1726 - 1750 19TH AVE

MUP Recommendation Packet | Project #3032760-LU/#3032763-LU | January 3, 2023

1726 19th Avenue - Project Number 3032760-LU

1730 19th Avenue - Project Number 3032763-LU

1. Street View looking Southwest

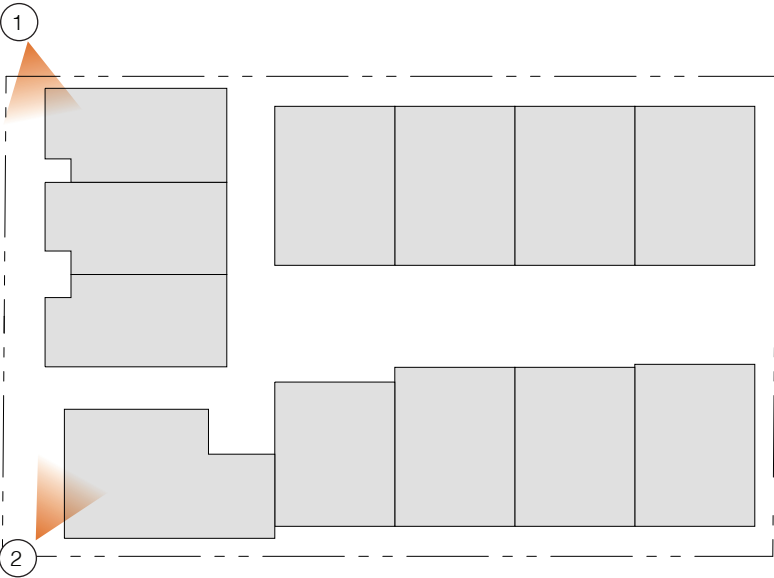
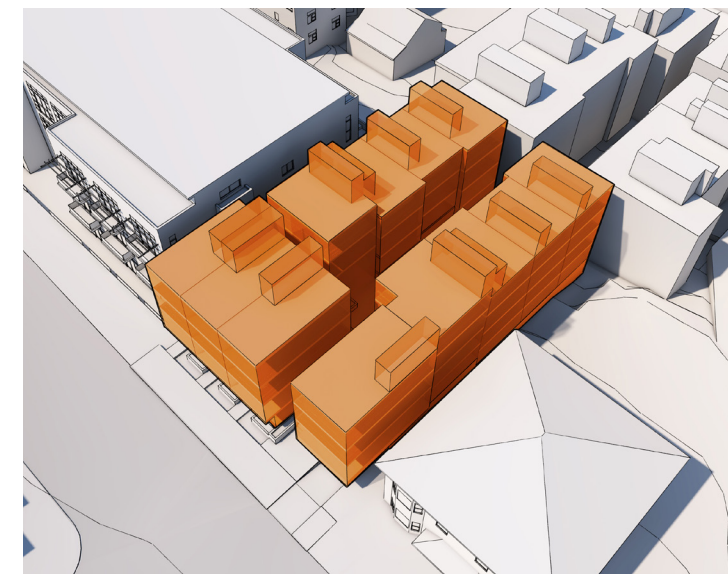
- ii. Staff generally supports the siting of the overall massing. However, Staff has concerns with the street-facing upper-level massing. Additional discussion concerning this subject is found in item #2.c.i (CS2.C.2)

- The massing of the proposed scheme has been developed to further encourage interaction through a network of open spaces and exterior circulation. The central courtyard, strong street edge, and west facade modulation have been retained and refined in response to guidance.

12. Street View looking East

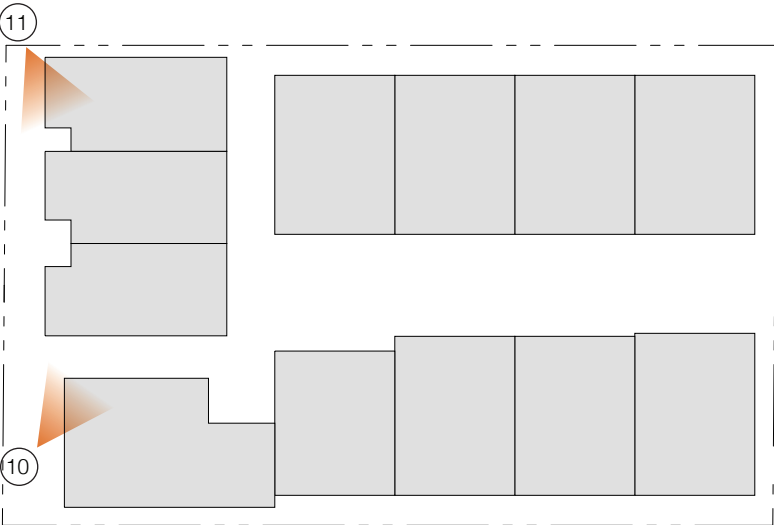
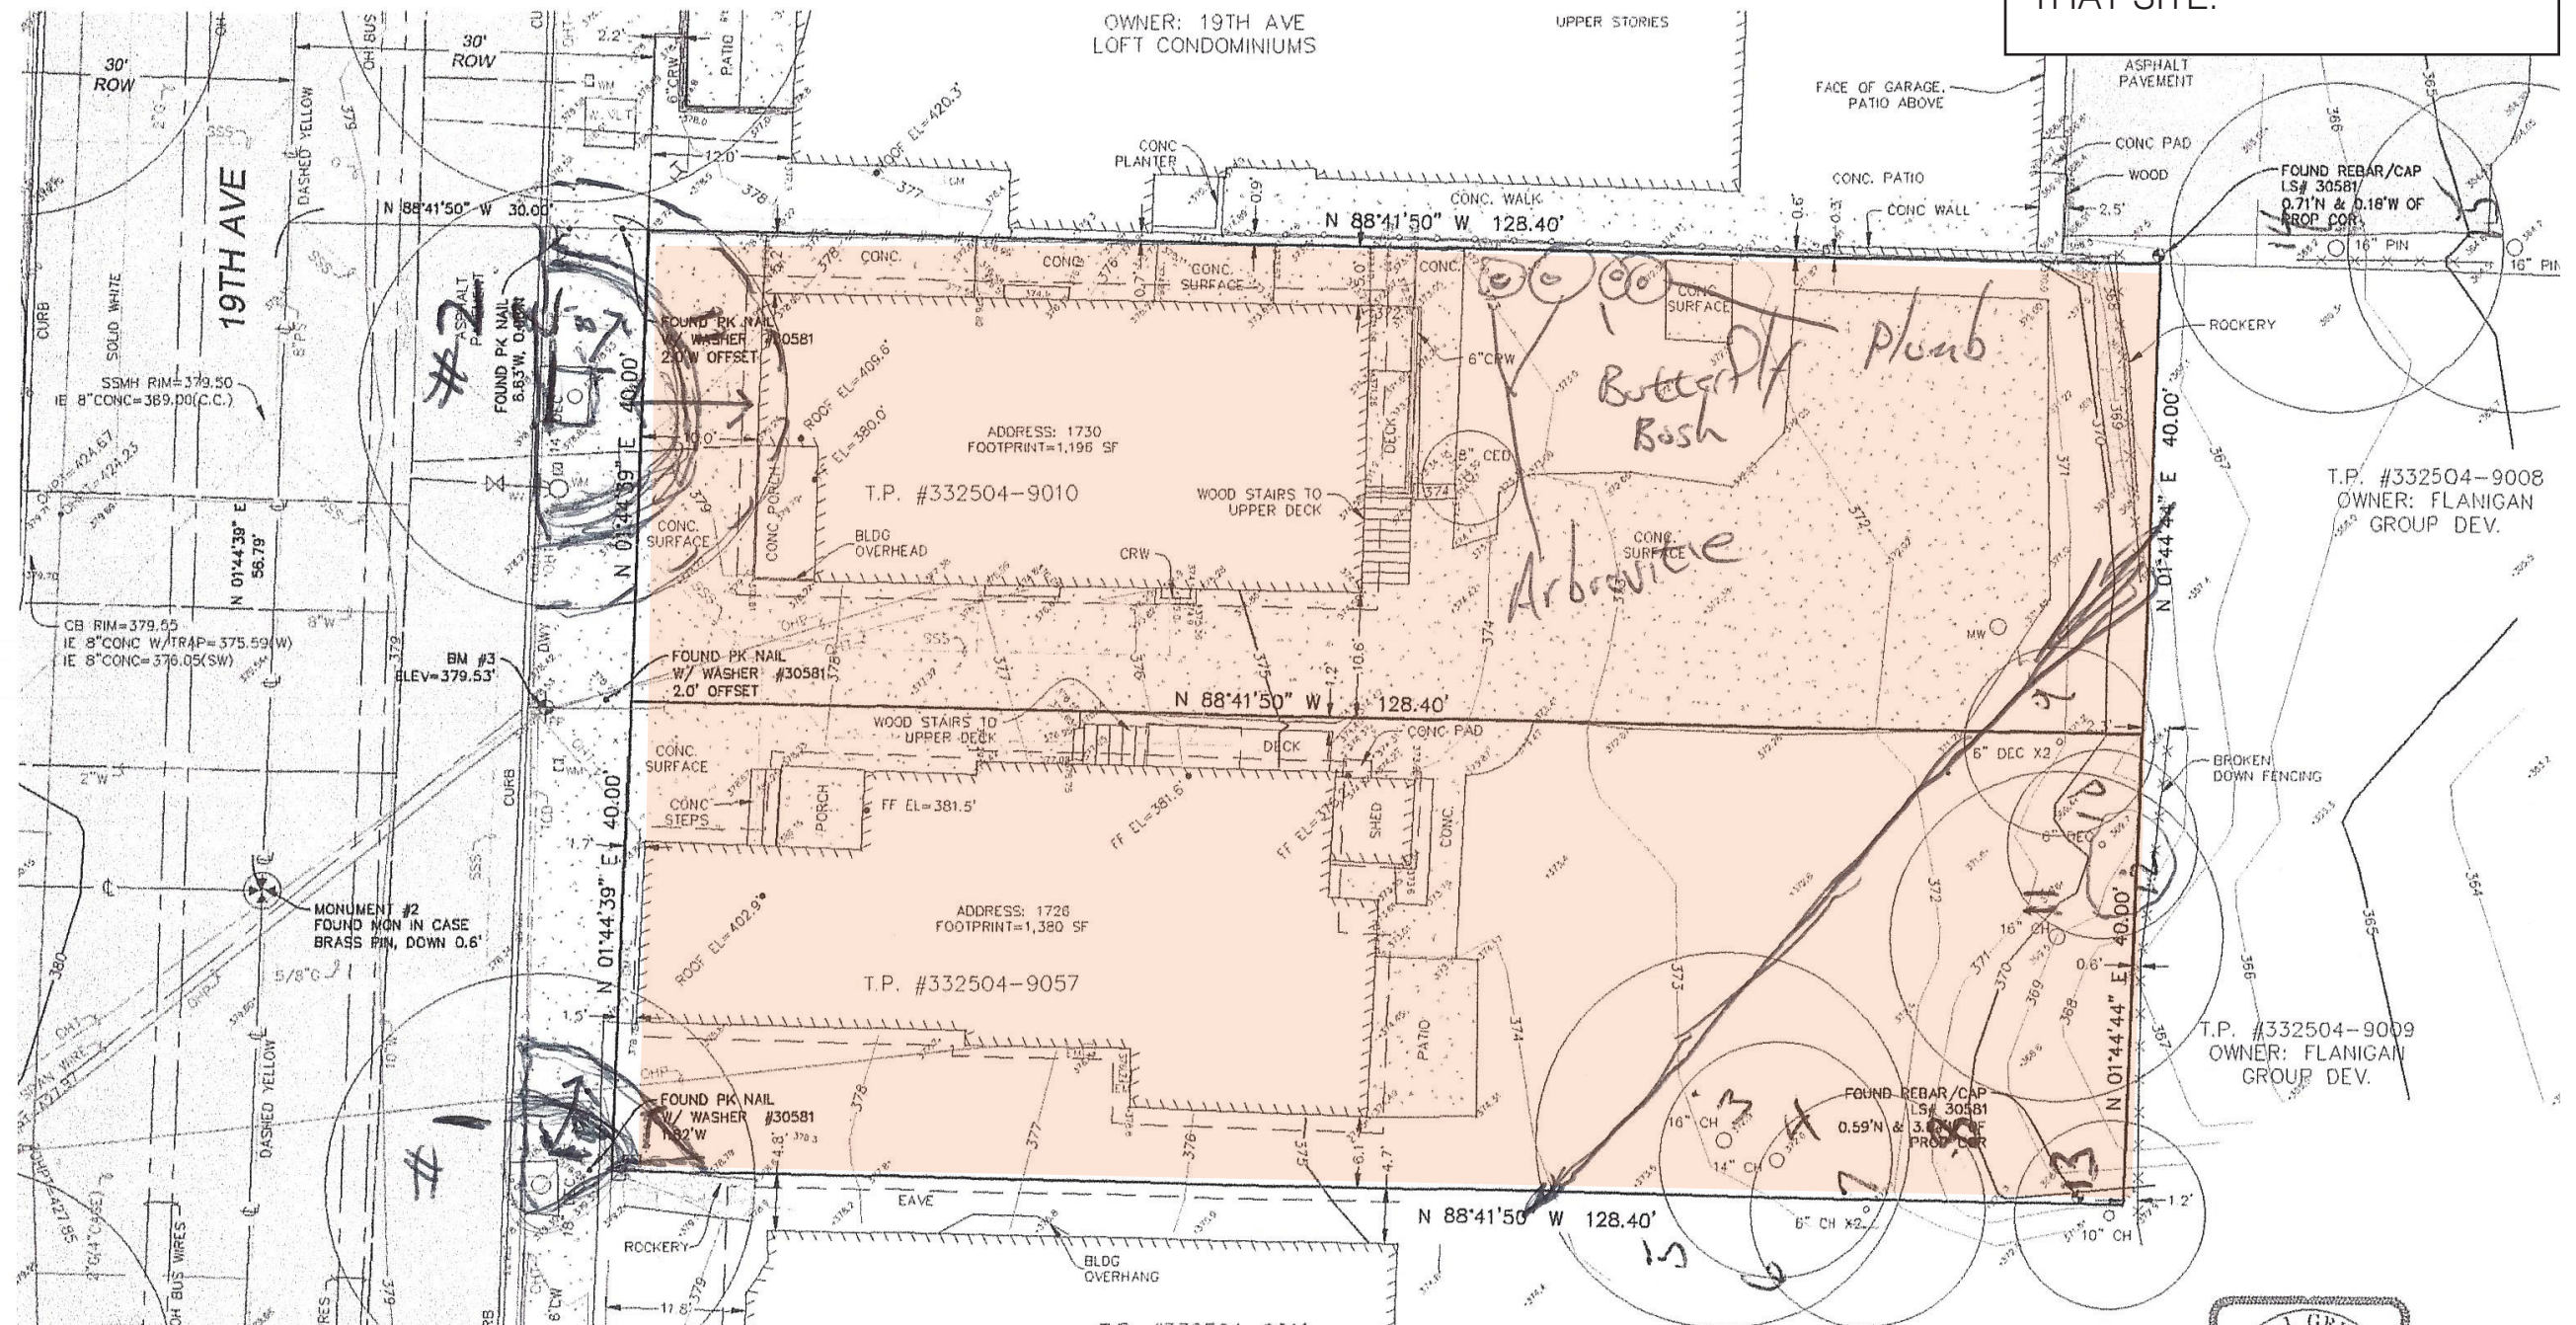
- a. SDCI expects to review an ensemble of elements (doors, canopies, railings, hardscape, landscaping, glazing, seating, screening, etc.) that encourage interest at the streetlevel and clarify building entries/edges. Conceptual lighting designs proposed for the building's street facing and surrounding façades should also be offered during the ADMINISTRATIVE EARLY DESIGN GUIDANCE #3032517-EG Page 5 of 21 MUP phase of design development. (PL2.B, PL3.A, PL3.B, DC4.C, DC4.I CAPITOL HILL, D4.II CAPITOL HILL)

- i. Staff, in consideration of public comment, also observes that the upper-level massing abutting 19th Avenue may negatively impact the viability/health of the existing stately tree that is currently oriented near the site's southeast corner protruding over the sidewalk and onto the project site; and strongly encourages that this tree be preserved. Staff recognizes that this tree is considered a "Street Tree" because it is planted in the 19th Avenue right-of way. Thus, the Seattle Department of Transportation (SDOT) has purview over Street Trees and potential street improvements. Staff expects the applicant to address this concern directly with SDOT during the initial Master Use Permit (MUP) review process and provide street improvement design specifics (Street Trees, landscaping, pavement, design elements, etc.)/SDOT feedback during the Recommendation phase of review. (DC3.I.v CAPITOL HILL, DC3.II CAPITOL HILL)

In response to the planner’s guidance, the design proposal is further developed in relationship to the neighboring structure to the east, also designed by the applicant, with particular attention paid to the visual and spatial connections between the courtyards.

13. Street View looking North

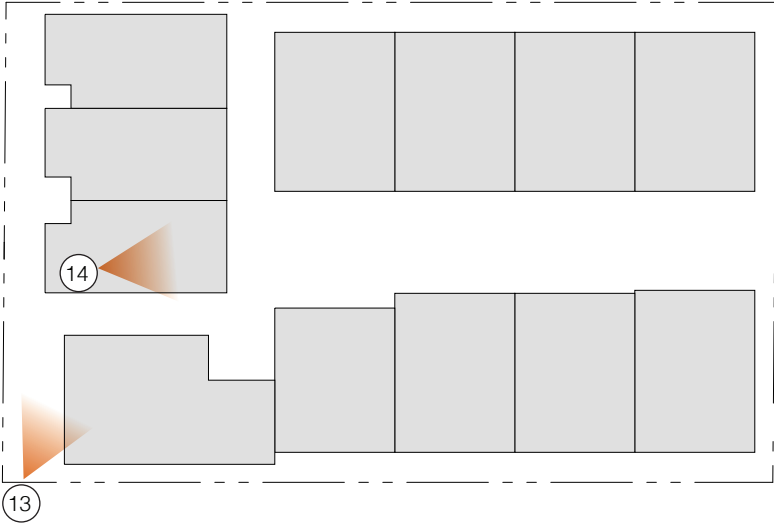
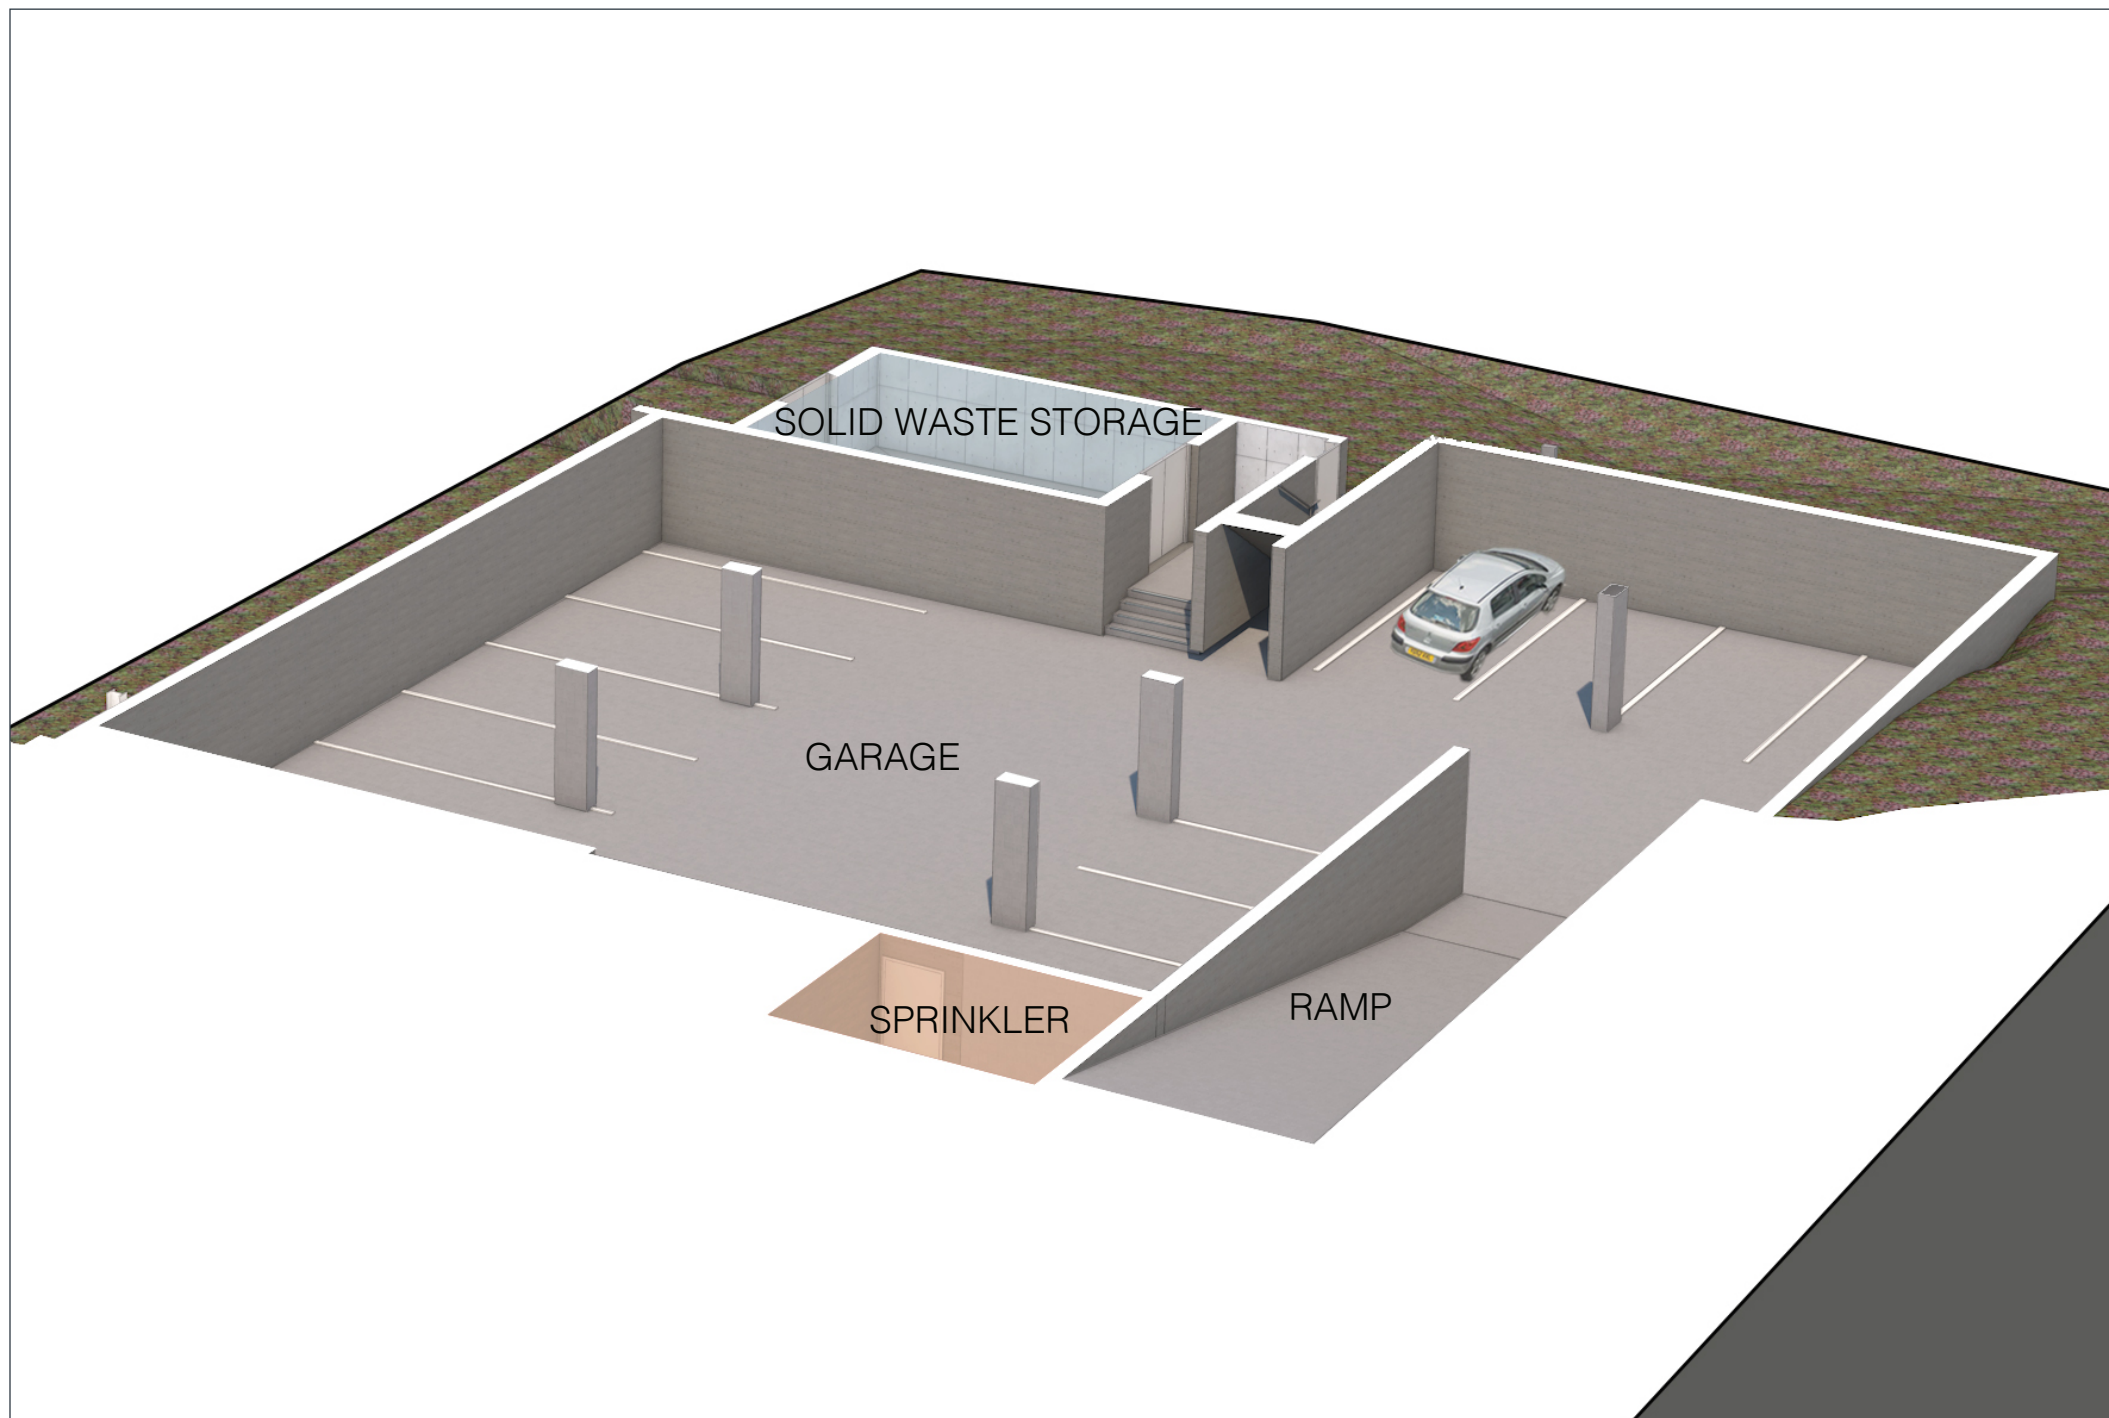
- a. In reviewing the site survey and considering the design intent to create onsite parking, Staff understands the need to allow vehicular access to garage parking via 19th Avenue. Staff expects that special attention to pedestrian safety be prioritized and incorporated in the next design iteration. (DC1.B.1)
- b. Staff expects that the garage door screening treatment to be carefully designed for pedestrian scale and visual interest, due to its dominance of the street-level street facing façade abutting 19th Avenue. (CS2.I.iii CAPITOL HILL, DC1.C.2, DC4.II CAPITOL HILL) ADMINISTRATIVE EARLY DESIGN GUIDANCE #3032517-EG Page 6 of 21
- c. Staff is pleased that the shared waste storage location is planned to be located within the parking garage and be accessible by waste providers from the alley. (DC1.C.4)

- a. One curb cut is provided on site to 14 parking stalls located within a shared below-grade parking garage. The vehicular access is separated from the private unit entries and common pedestrian walkway along 19th Avenue. Access to the unit above the driveway directly engages the 19th Avenue streetscape so all street facing units have entries visible from the street. Landscape elements, including planters, provide a physical barrier between the driveway and shared pathway. (DC1.B.1)

- b. The garage door is located in the southwest corner of the site, away from pedestrian access points. In addition,the garage door has been set back 10 feet from the front lot line and to reduce the presence of the door. Landscape planters provide a physical and textured buffer between the garage door and the pedestrian pathway. Furthermore the garage door is proposed to be textured, with an open metal frame, diminishing the amount of blank wall along the street edge. (CS2.I.iii CAPITOL HILL, DC1.C.2, DC4. II CAPITOL HILL)

15. Alley View Looking South

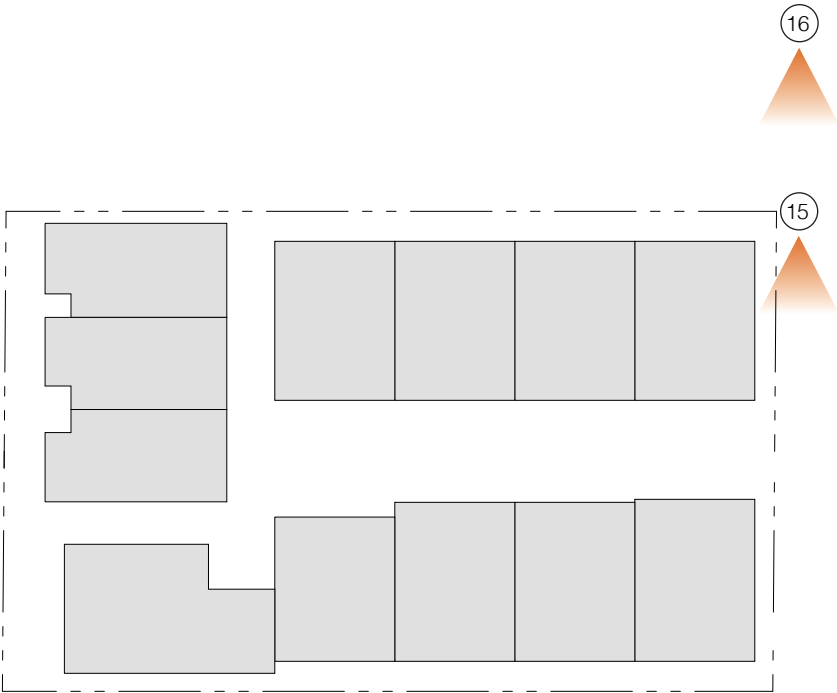
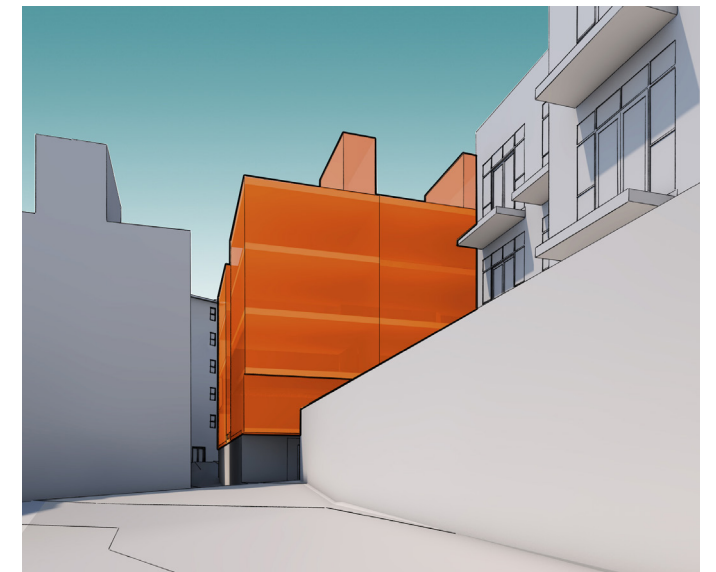
- d. Staff appreciates the applicant's intent to locate waste receptacles offsite in the shared waste storage room located in the neighboring townhouse development proposal's parking garage southeast of the project site. Staff is unsure that this offsite arrangement is compliant with solid waste location and access standards per the Land Use Code. Ultimately, it is important that the residential trash receptacles be located and screened away from pedestrian areas and the future design should address this concern appropriately. (DC1.C.4)

- d. As noted in the Early Design Guidance packet, shared solid waste storage is located below grade, within the adjacent shared parking garage. Waste service providers will access the waste storage area from the alley that terminates at the northern edge of the adjacent site. This will reduce the impact waste storage and collection has on adjacent structures, pedestrian areas and vehicular traffic. Seattle Public Utilities has reviewed the proposed waste area and has provided an approval letter. (DC1.C.4)
